## Summary of disputed items

Item 1.

Amtico flooring laid uneven.

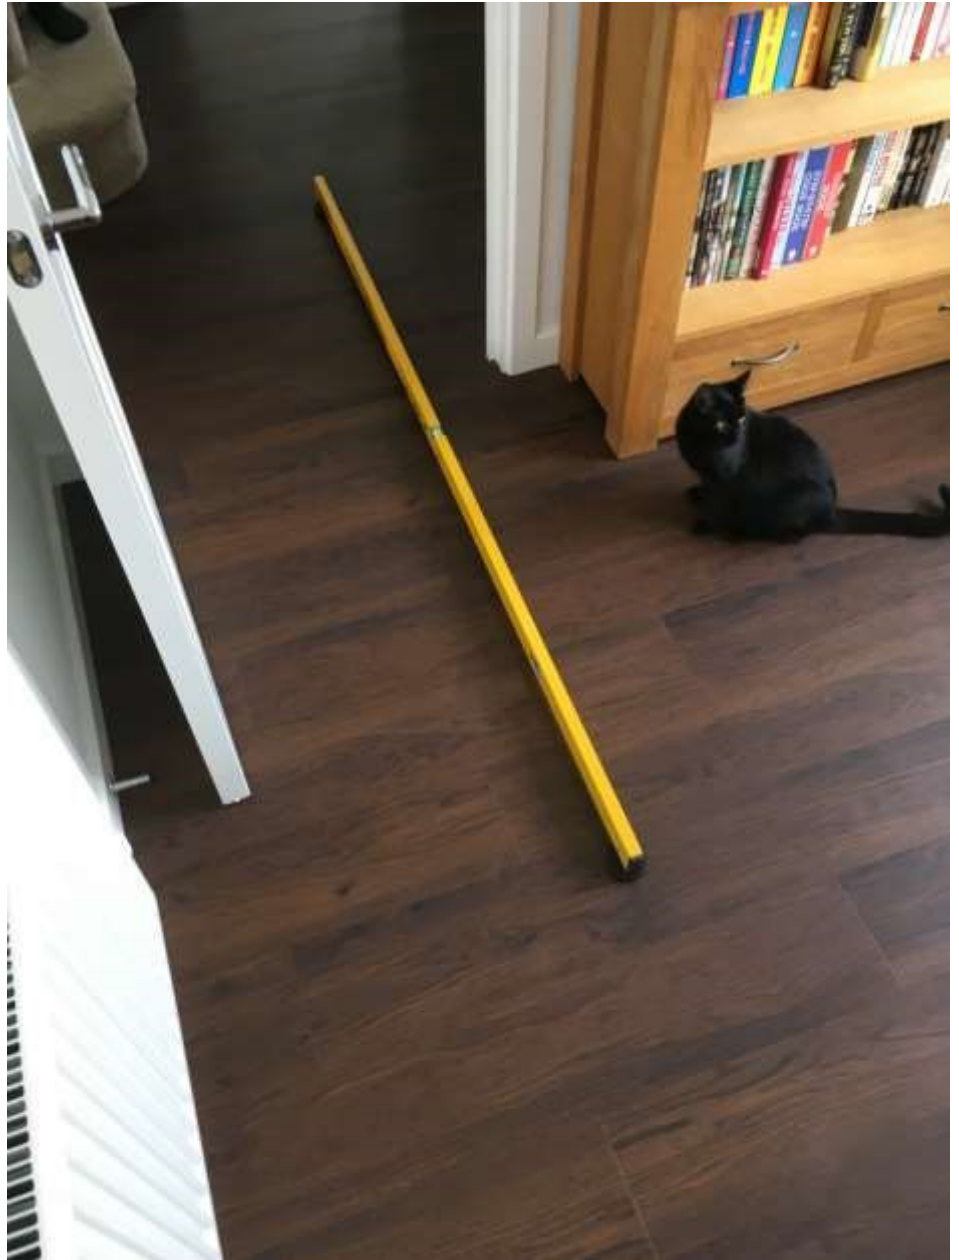
*Amtico floor finish to kitchen. Excessive dip in floor to area below spirit level.*

*Dip measured at 20mm. 10mm offsets used below ends of 2m straight edge.  
NHBC tolerance is +/- 5mm using a 2 metre straight edge with equal offsets.  
Dip therefore 5mm over allowable tolerance and considered excessive.*

I recommend that the builder undertakes work to rectify the highlighted excessive dip in the floor between the kitchen base unit and the tall fridge freezer unit, and also to the cloakroom floor. Re-levelling work should bring the floor to within NHBC tolerances of +/- 5mm, and may require the temporary removal of some kitchen units and cloakroom sanitary ware along with areas of the Amtico floor covering.

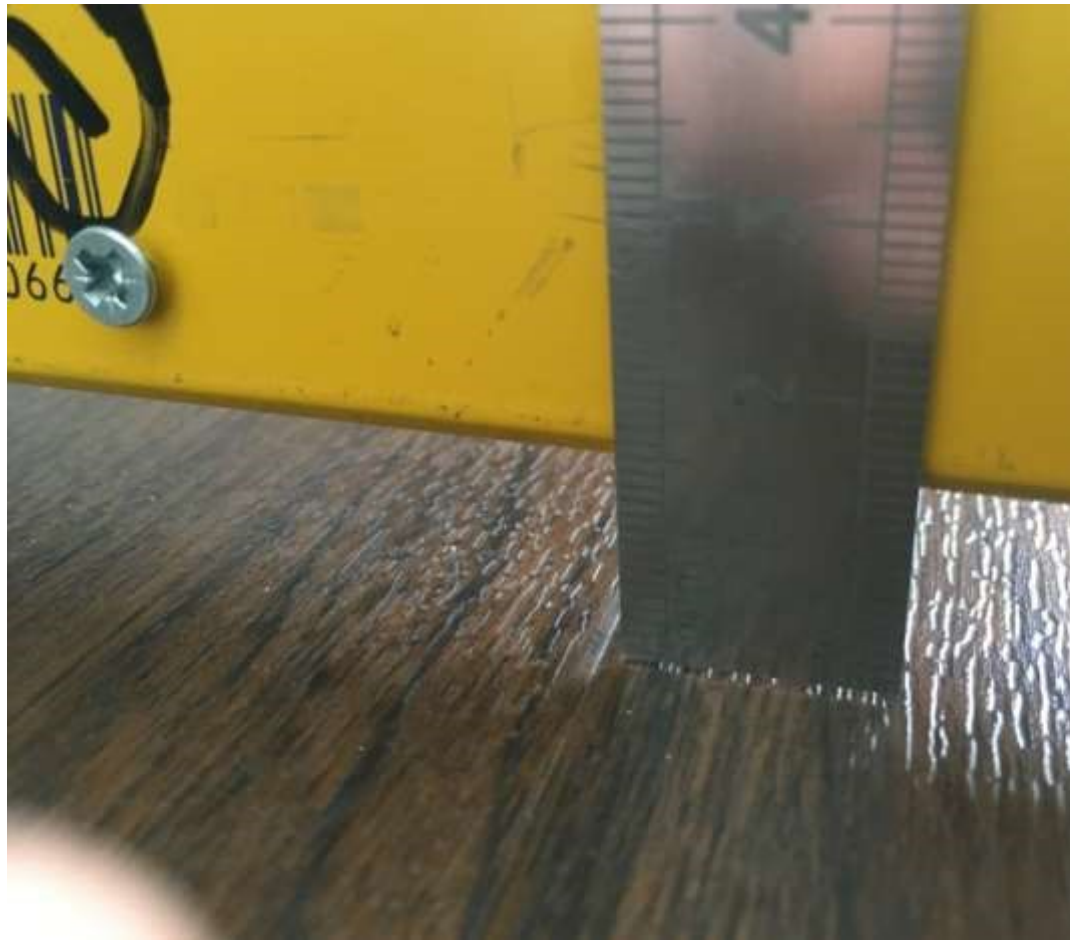
*Excessive dip in floor runs through into cloakroom.*

*Dip measured at 19mm. 10mm offsets used below ends of 2m straight edge. NHBC tolerance is +/- 5mm using a 2 metre straight edge with equal offsets. Dip therefore 4mm over allowable tolerance and considered excessive.*

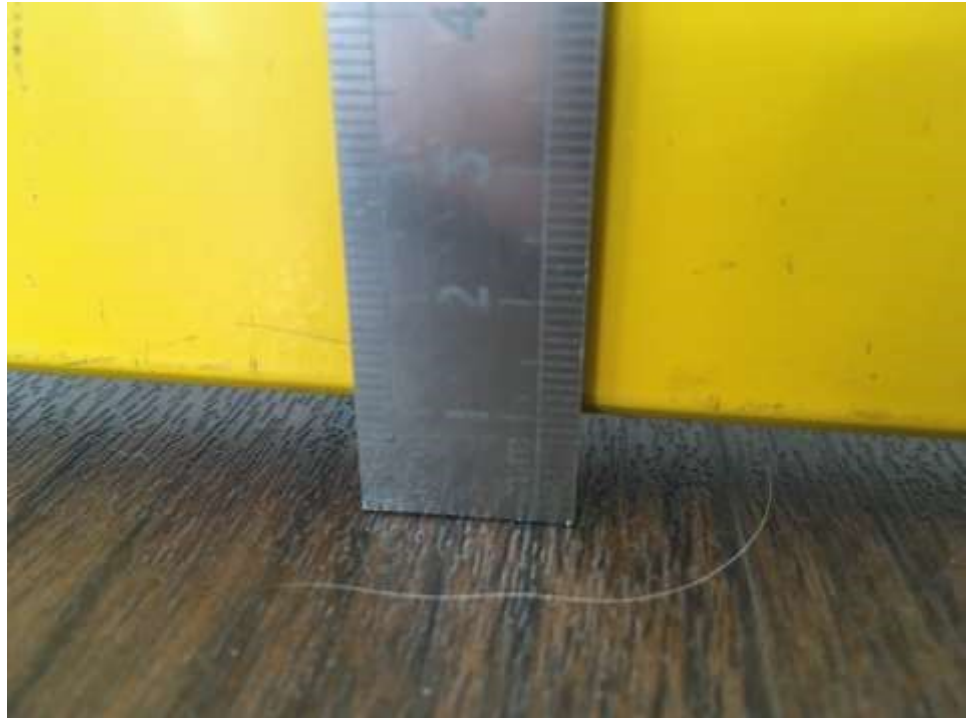
*Floor measured across dining room square bay.*

*Dip measured at 12mm. 10mm offsets used below ends of 2m straight edge. NHBC tolerance is +/- 5mm using a 2 metre straight edge with equal offsets. Dip therefore 3mm within allowable tolerance and considered acceptable.*

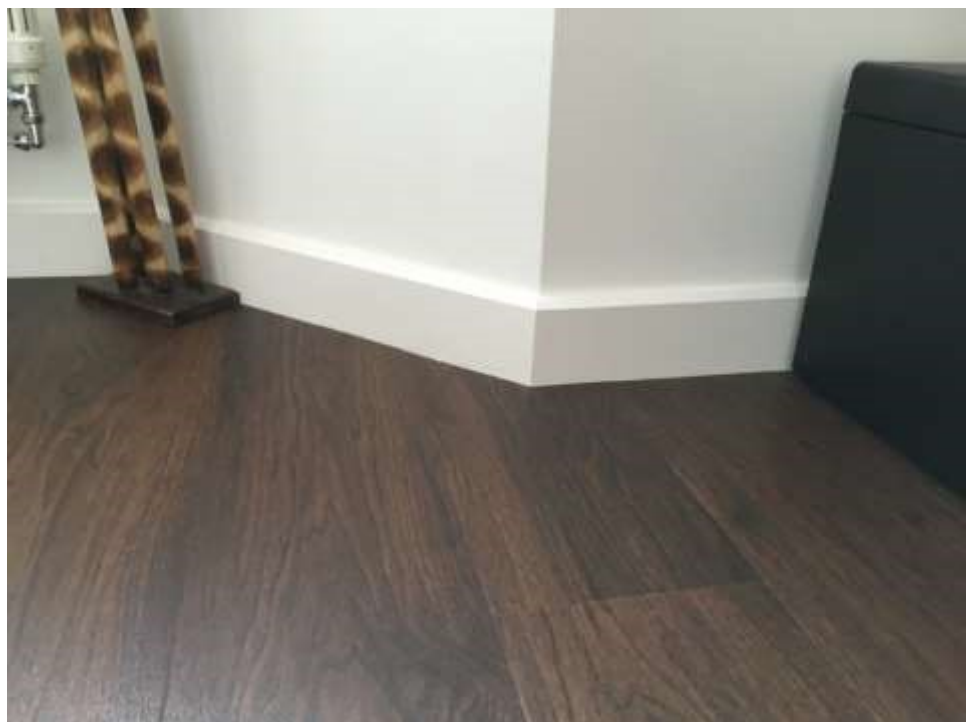
*Visual appearance of Amtico floor finish against skirting lines. Localised hump in floor due to debris below Amtico floor present to area highlighted.*

Mr Ball also pointed out a localised bump in the Amtico floor in the dining room, caused by some debris below the surface. This area is highlighted in the above photograph.

In addition, the localised debris below the Amtico floor in the dining room where highlighted in the above photograph should be removed by the builder.
